# Technical product information

<b>Topic</b>	Bentayga V8 Kovomo - DTC P227900 evident within the engine control unit 0001
<b>Market area</b>	United States E05 Bentley USA and rest America (6E05)
<b>Brand</b>	Bentley
<b>Transaction No.</b>	2071575/2
<b>Level</b>	EH
<b>Status</b>	Approval
<b>Release date</b>

Figure 2

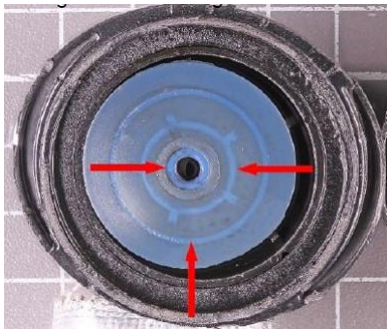
**Hint:** The diaphragm of 0P2 103 210G and 0P2 103 211H are blue (Figure 2)

0P2 103 211H

0P2 103 210G

Figure 4

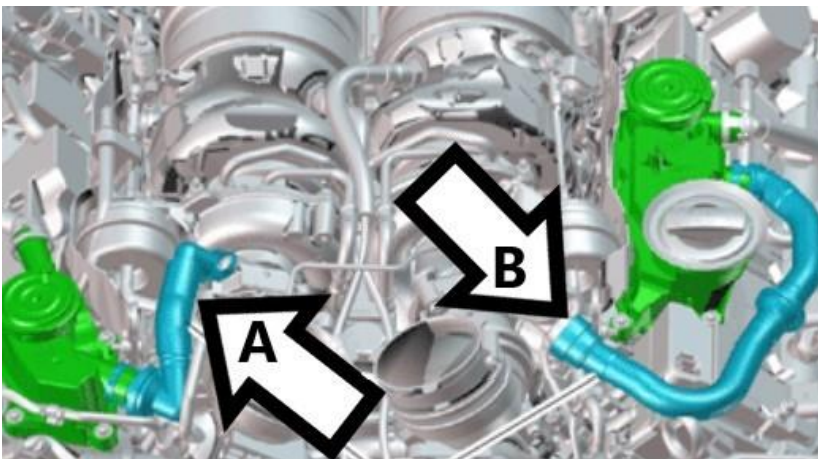
Referring to Figure 4

- Point A - Is the bank 1 (right) turbocharger full load pipe
- Point B - Is the bank 2 (left) turbocharger full load pipe

1) Referring to Rep.Gr 21 - Replace the bank 1 (right) and bank 2 (left) turbocharger full load pipes

Note: when conducting the instructions within this TPI please ensure the bank 1 and bank 2 turbocharger full load pipes are replaced in pairs (during the same workshop visit)

Figure 5

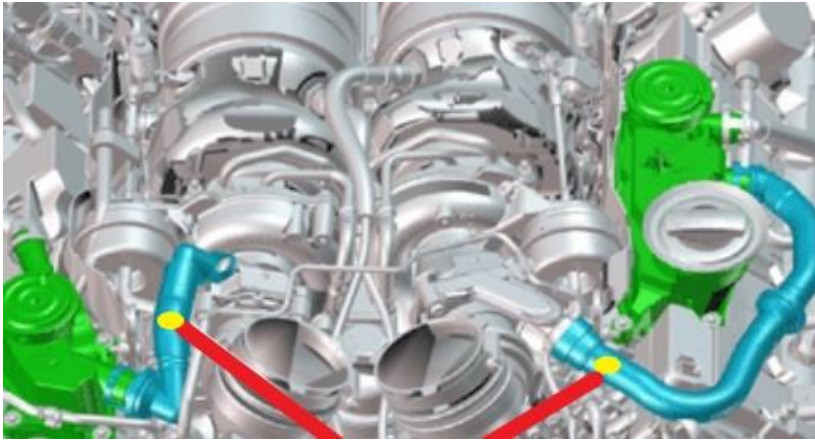
2) To confirm both pipes have been replaced using the H level parts the operative must place a yellow paint mark as shown in Figure 5
